RE: Response to Comments

**Mary River Mine Site Fuel Storage Facility and 15 ML Arctic Diesel Tank
Mary River Project - Type 'A' Water Licence - 2AM-MRY1325 - Amend. No. 1**

Baffinland Iron Mines Corporation (Baffinland) provides the attached response to comments on the planned construction of the Mary River Mine Site Tank Farm at the Mary River Project. Responses to comments received from the Qikiqtani Inuit Association (QIA) and Crown Indigenous Relations and Northern Affairs Canada (CIRNAC) are provided in Attachment A.

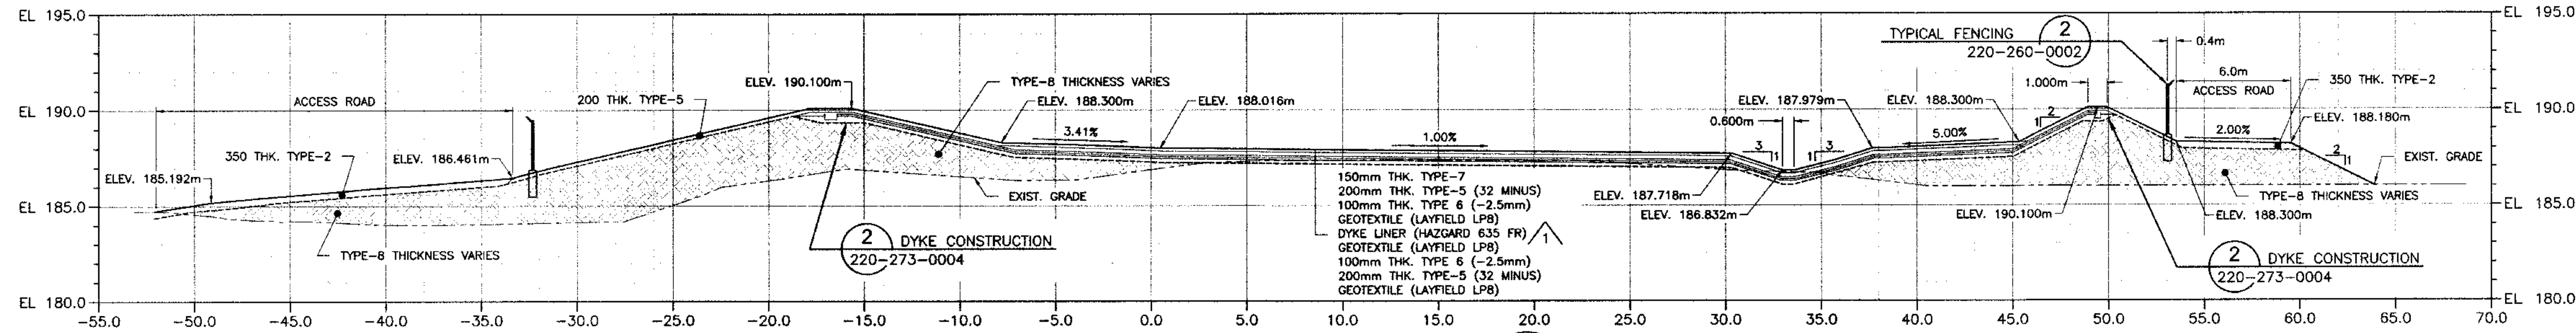
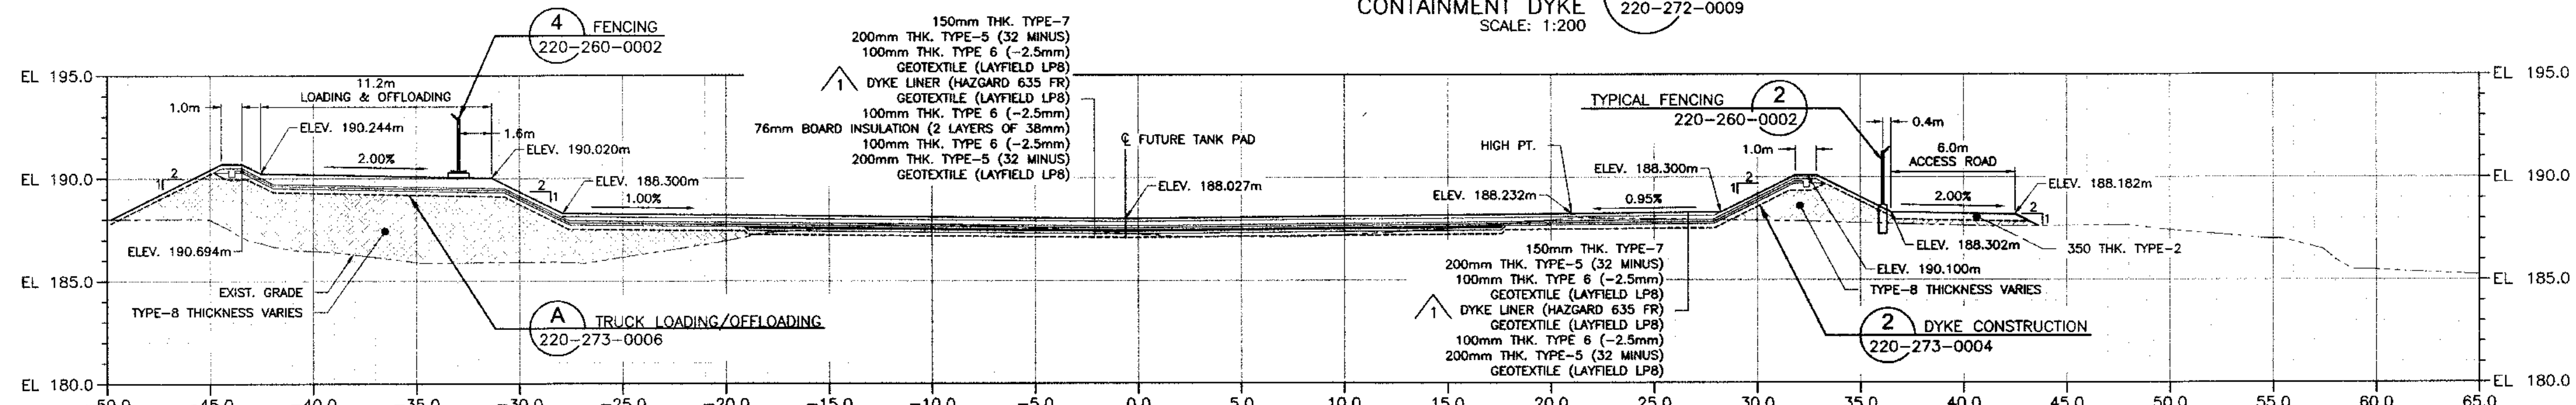
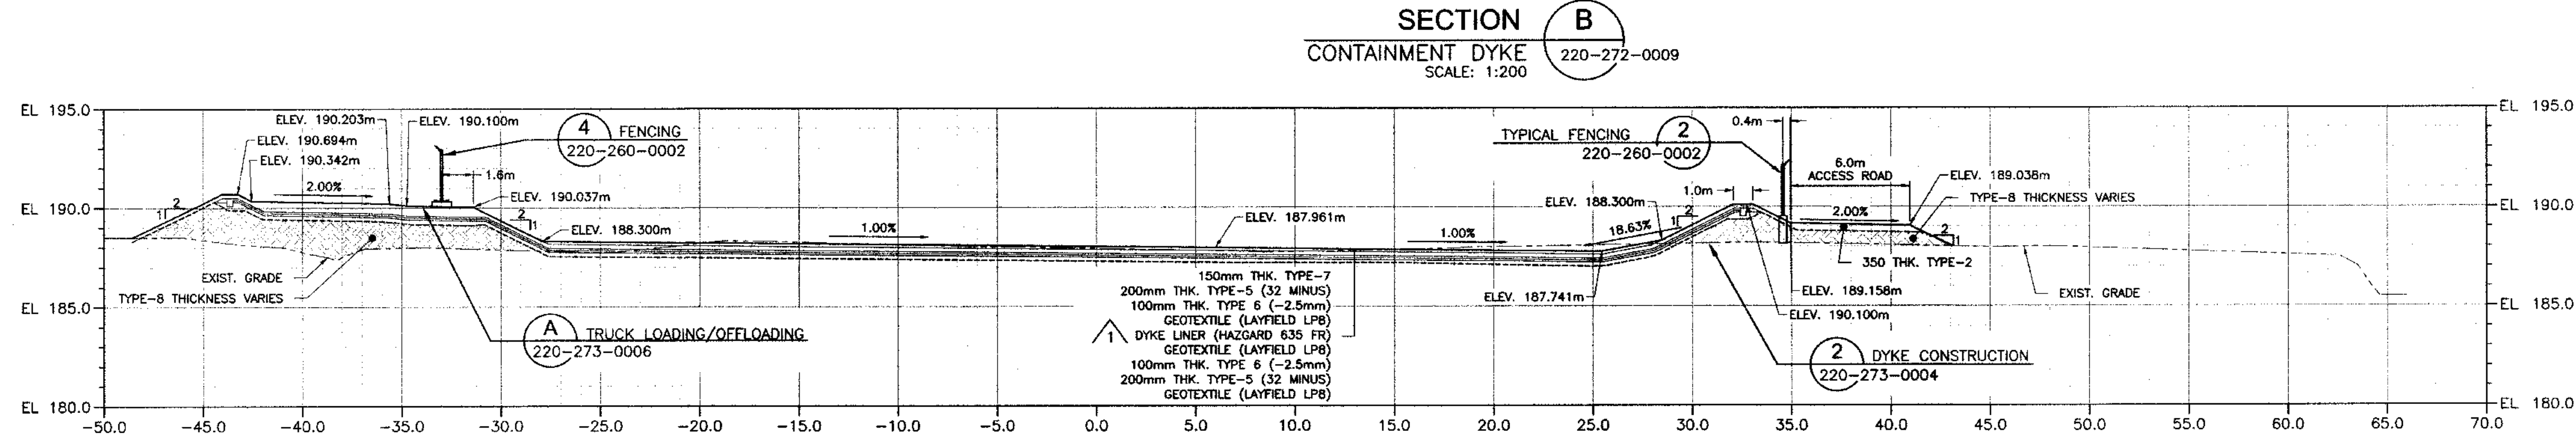
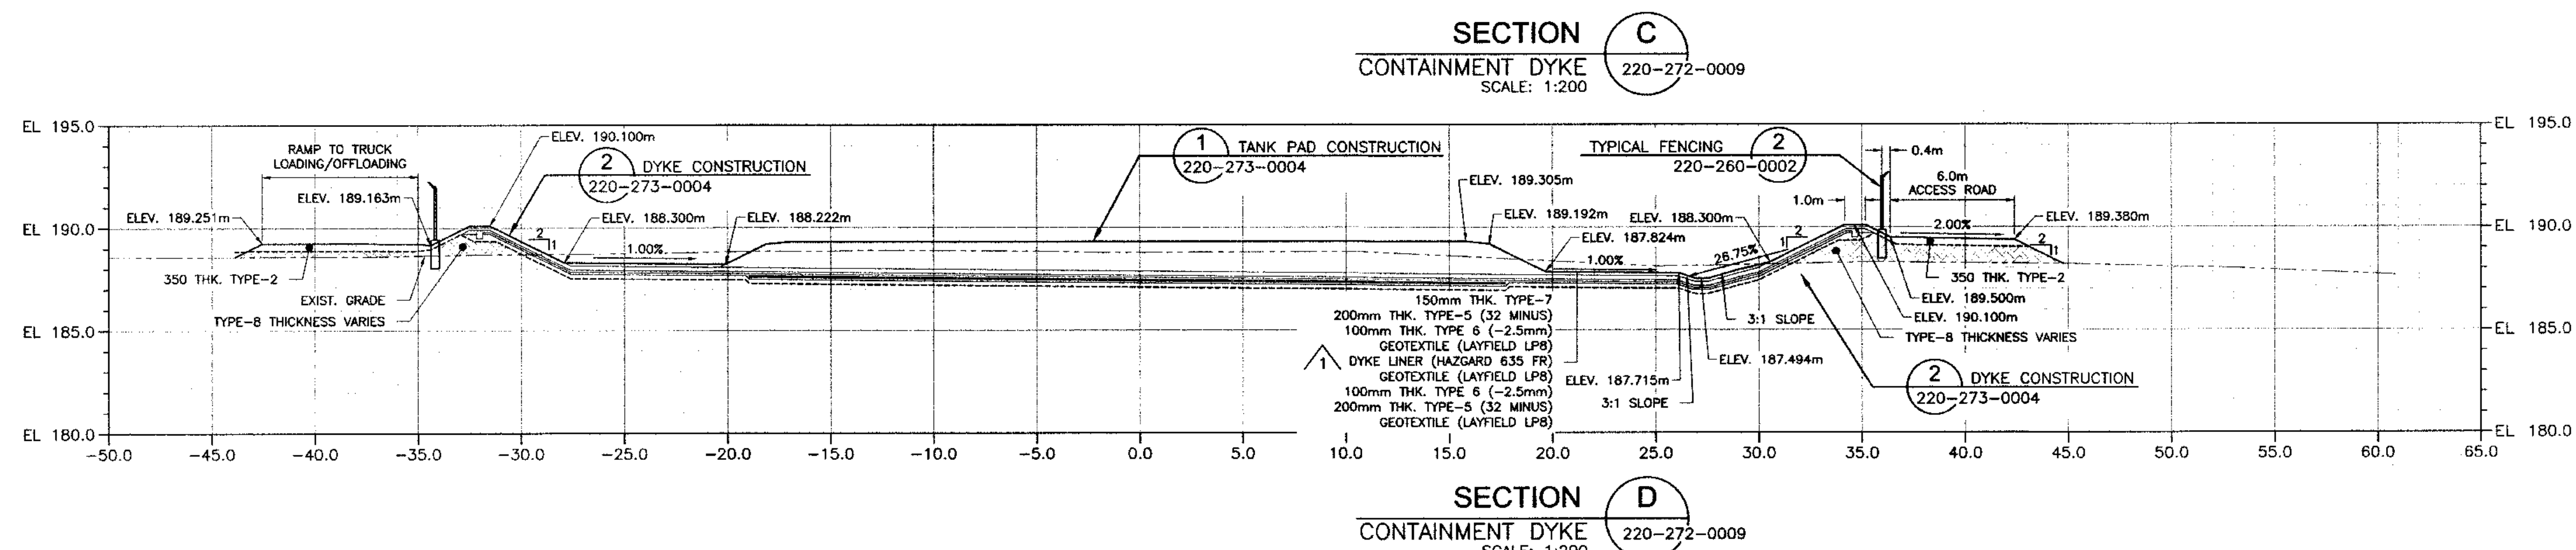
No.	DESCRIPTION	BY	CHK'D	DATE
1	SECTIONS UPDATED TO SUIT REVISED DYKE AND ACCESS ROAD LAYOUT, LINER TYPE REVISED	SJM	KML	18-07-25
0	ISSUED FOR CONSTRUCTION

MINE SITE
TANK FARM
GENERAL ARRANGEMENT

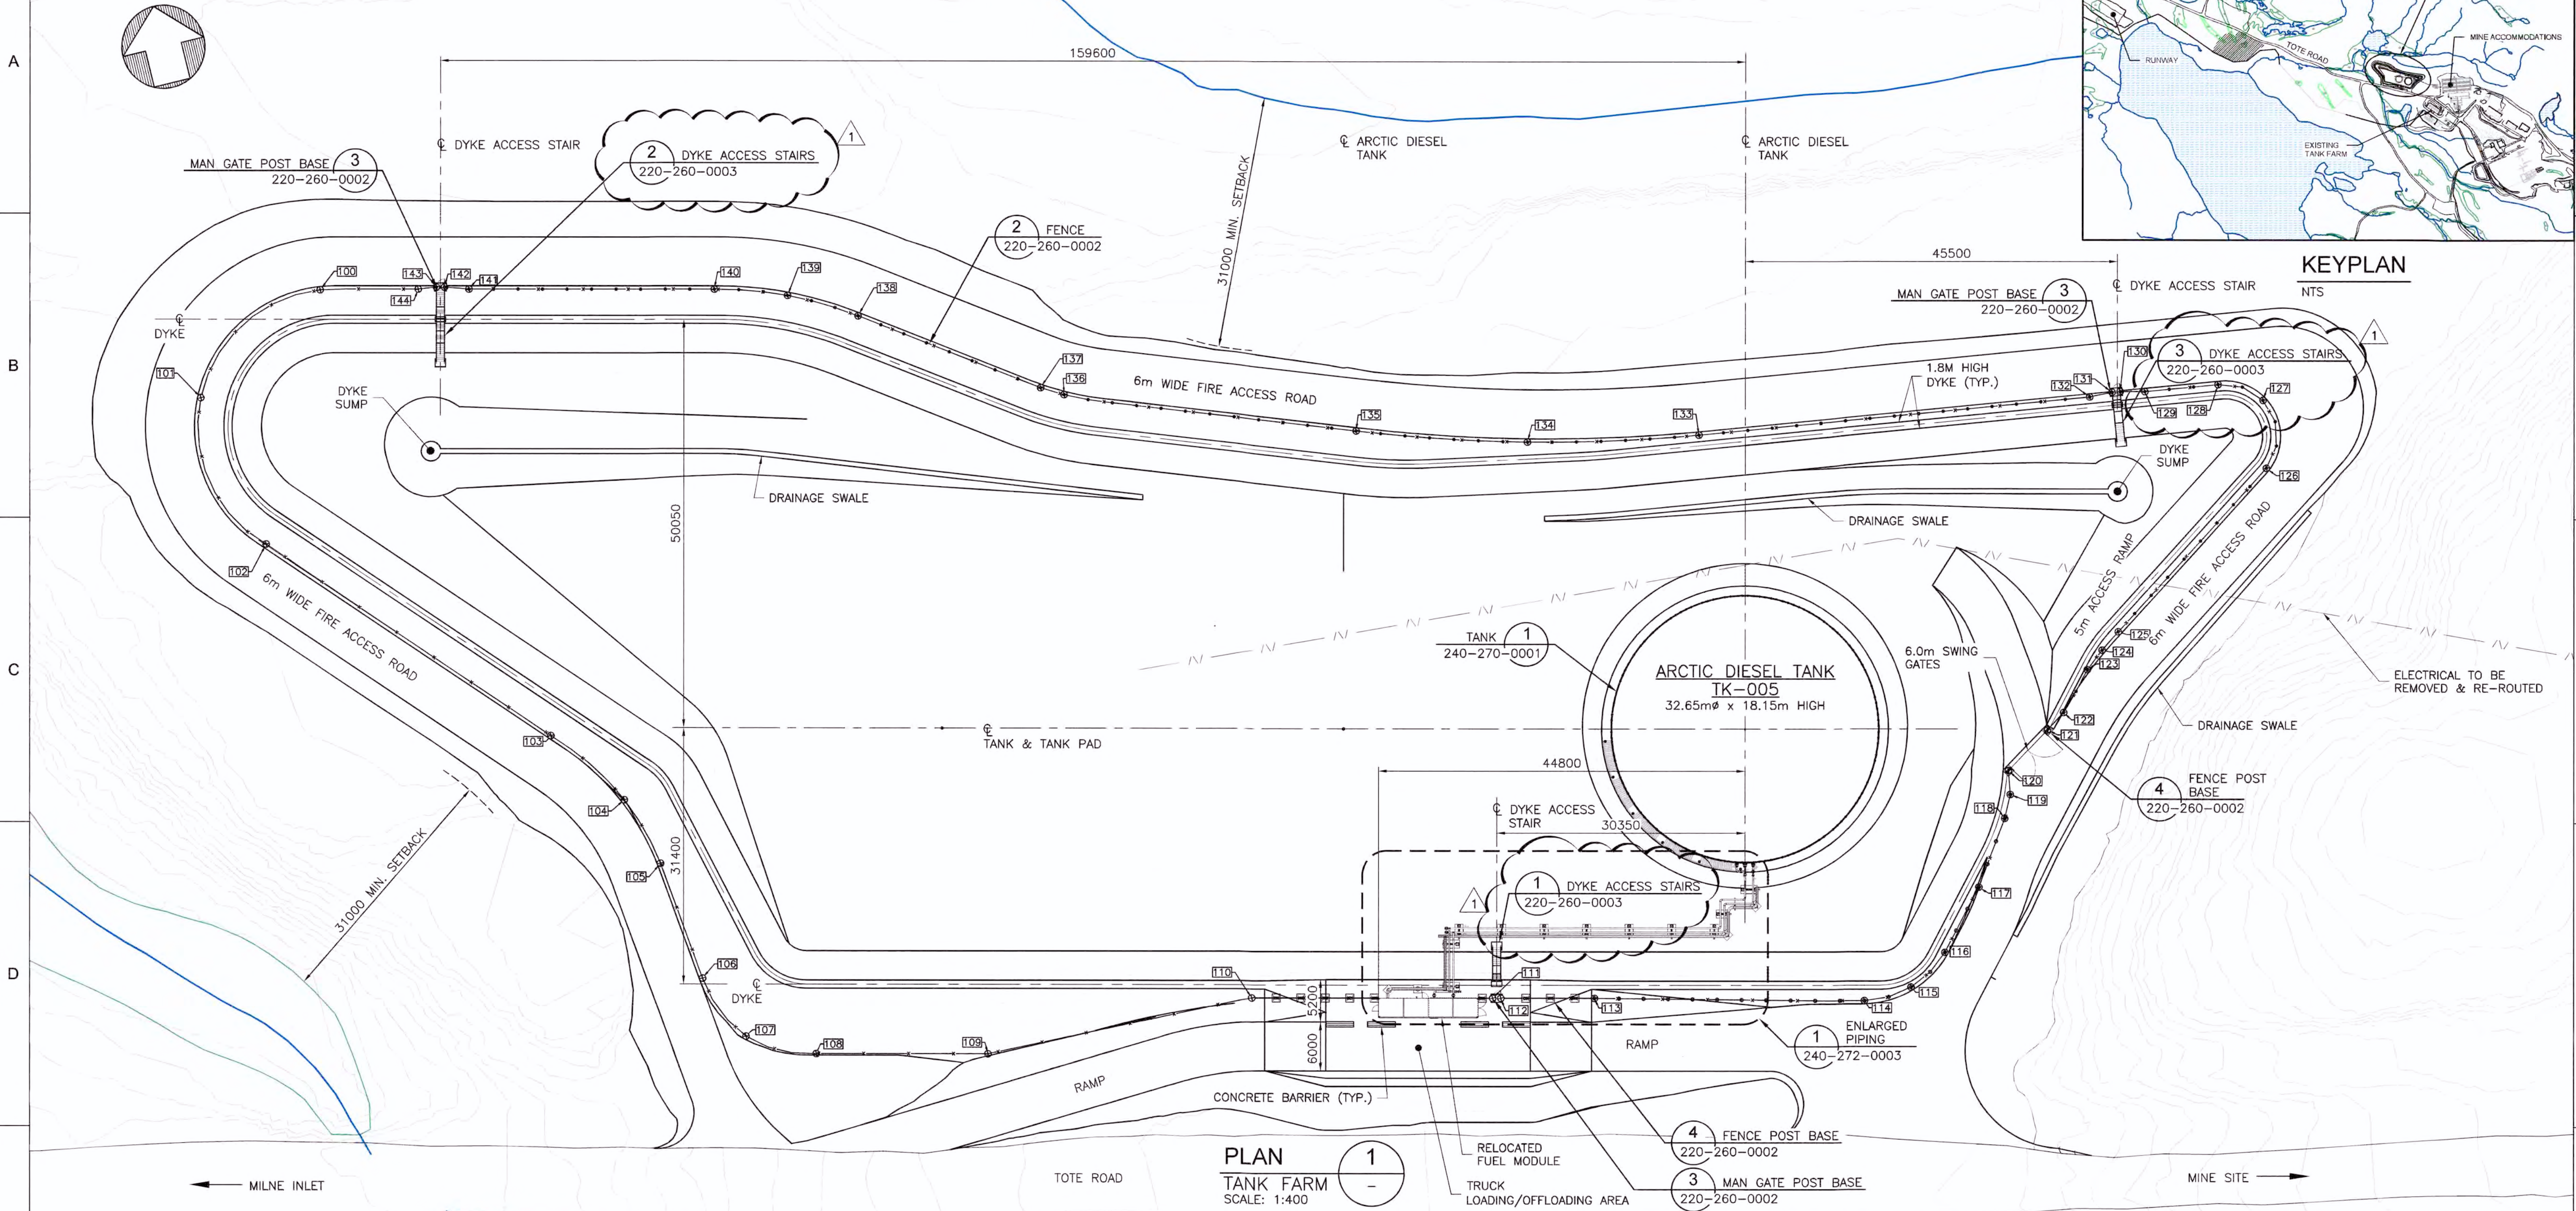
No.	Comment	Baffinland Response
5	<u>Comment:</u> CIRNAC notices from the construction drawings presented in Baffinland's Notification of Planned Construction Work that the berm is scheduled to be constructed within thirty- one metres (31 m) of a stream. CIRNAC would like to remind Baffinland that the Licence 2AM-MRY1325 - Amendment No. 1 states in Part D, Item 25: <i>The Licensee shall prevent the deposition of debris or sediment from entering into or onto any Water body, with respect to the construction of access roads, site laydown pads and areas or other earthworks. These materials shall be disposed of at a distance of at least thirty-one (31) metres from the ordinary High Water Mark in such a manner that they do not enter the Water.</i>	The layout design of the Tank Farm facility has been adjusted to ensure construction does not encroach on the 31 metre distance from the high water mark. The revised drawings are provided as Attachment B.
